1	P1	PRELIMINARY ISSUE	7/5/14
REV No	REMARK	REVISION DESCRIPTION	REVISION DATE
<b>elitemetalcraft</b>			
DRAWING TITLE		A1_GA_DRAWING	
CONTRACT			
MODELLED BY	SO	ISSUE DATE	00.00.0000
CONTRACT NO	41489	SCALE	1:20
DRAWING No	G [2]	REVISION No.	1

3d

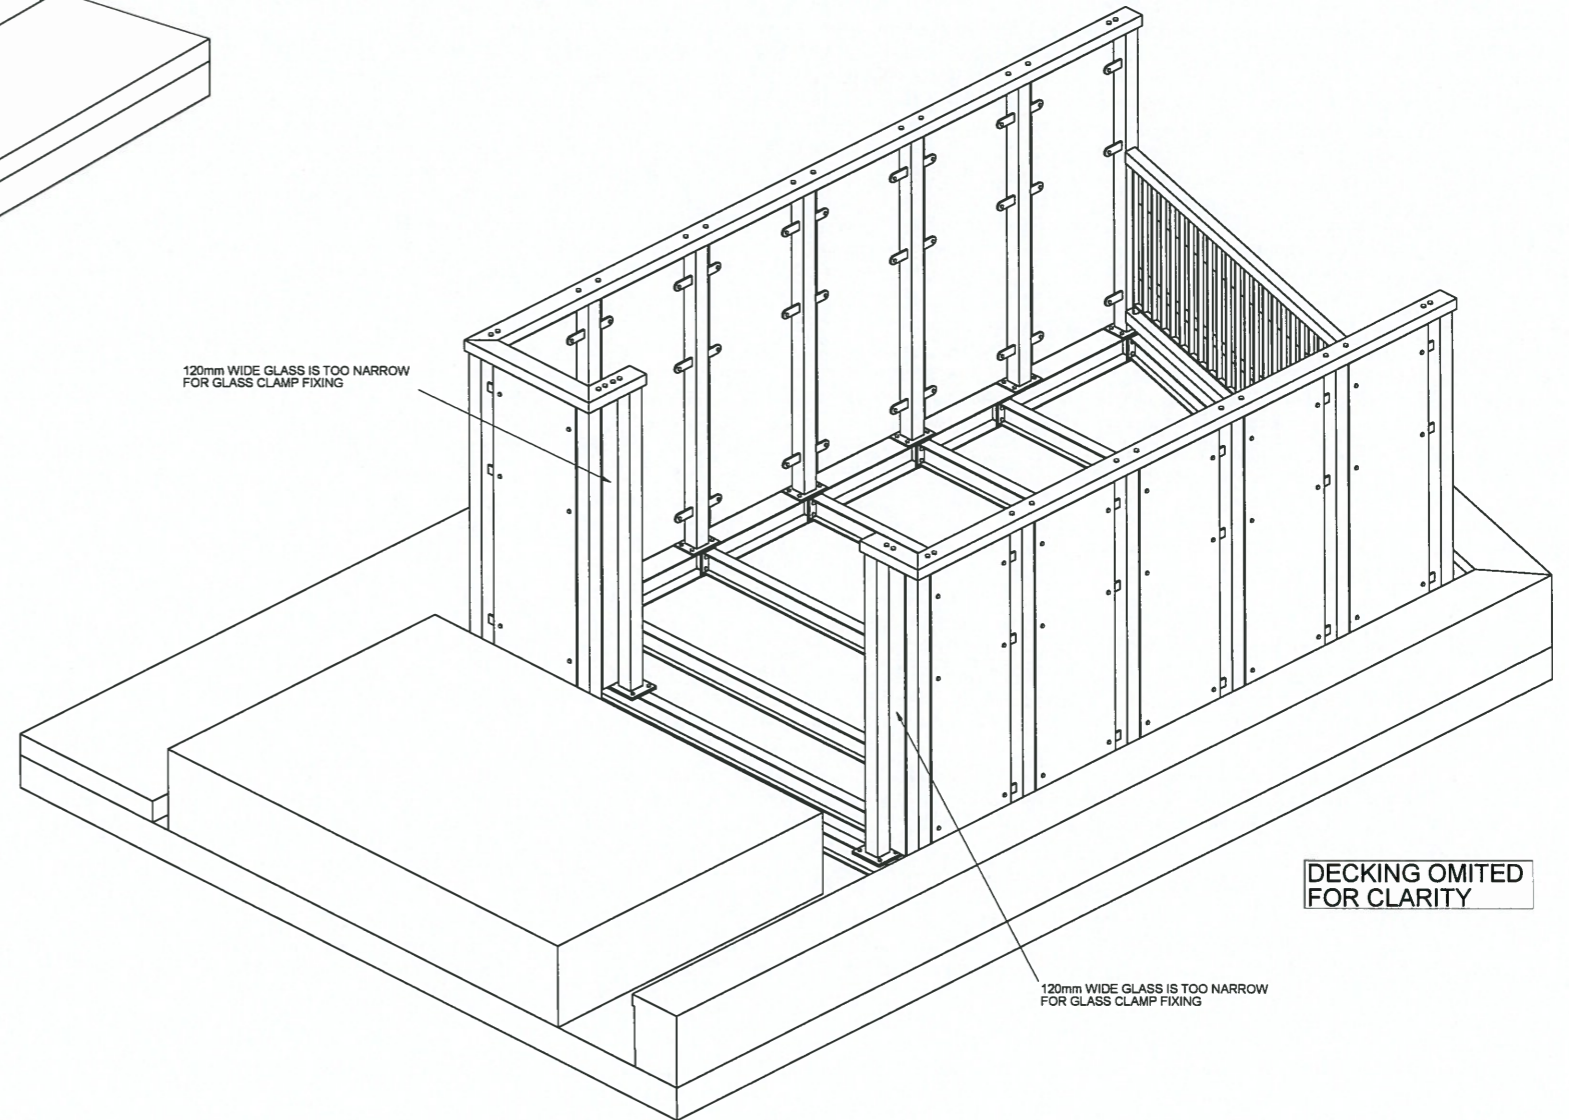
120mm WIDE GLASS IS TOO NARROW FOR GLASS CLAMP FIXING

120mm WIDE GLASS IS TOO NARROW FOR GLASS CLAMP FIXING
